Relevant Information for the Local Planning Panel

FILE: D/2017/1552 **DATE:** 3 July 2018

SUBJECT: Information Relevant To Item 5 – 26-30 City Road, Chippendale

Figure 1: View from the sun at 9am. The red line shows the height of the fence, corresponding to that of the southern boundary and therefore restricting solar access.

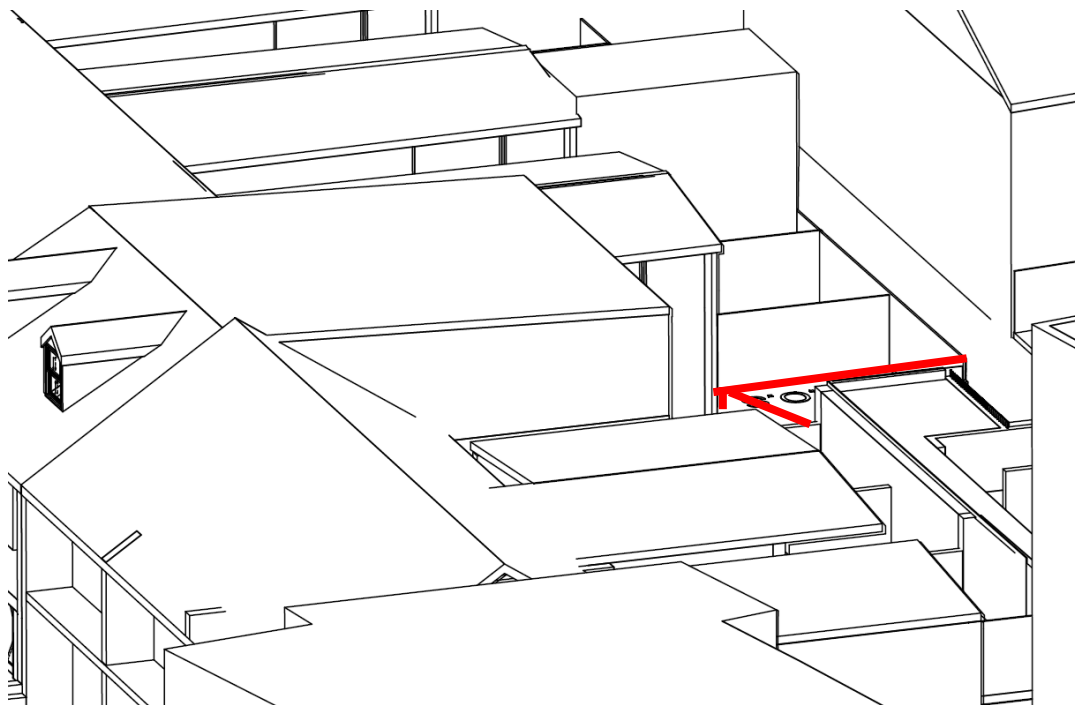
Response: The revised solar access diagrams at Attachment B do not accurately represent the existing and proposed built form of the existing Rose Street terraces, particularly regarding the provision of fences. As shown in figure 1 below, the height of the fence on the north boundary of no. 35 Rose Street is not accurately represented. It is noted that the existing ground level at nos. 35 and 37 Rose Street is higher than that at the rear of the proposed terrace houses and as such the fence between the proposed terraces and no. 35 Rose Street is likely to be higher than that shown on the diagrams.

At 10am, solar access to the rear of nos. 35 and 37 will be retained. At 11am solar access to the rear of the terraces will see a slight improvement. However officers are of the opinion that, contrary to the applicant's statement, the rear of the properties do not currently receive solar access at midday and will continue to be overshadowed due to the former Grace Bros. building.

Between 1pm and 3pm, the rear of no. 37 Rose Street currently receives some solar access, which will be lost without the reduction in the scale of the boarding house. This will have a lasting impact not only during midwinter but potentially for the days and weeks either side.

As such, and with regard to the matter of bulk and scale, Council officers reaffirm their assessment in the planner's report that, as the development exceeds the maximum 15 metre Sydney LEP 2012 height standard and 3 storey height control, the development should minimise impacts to the character and amenity of the surrounding area. Reducing the scale of the building will improve solar access to the private open spaces of nos. 35 and 37 Rose Street as well provide a transition in scale from City Road to Rose Street. While the modification will result in the loss of potentially 8 rooms, the development will still provide approximately 65 low rent boarding rooms. The deletion of the condition is not supported.
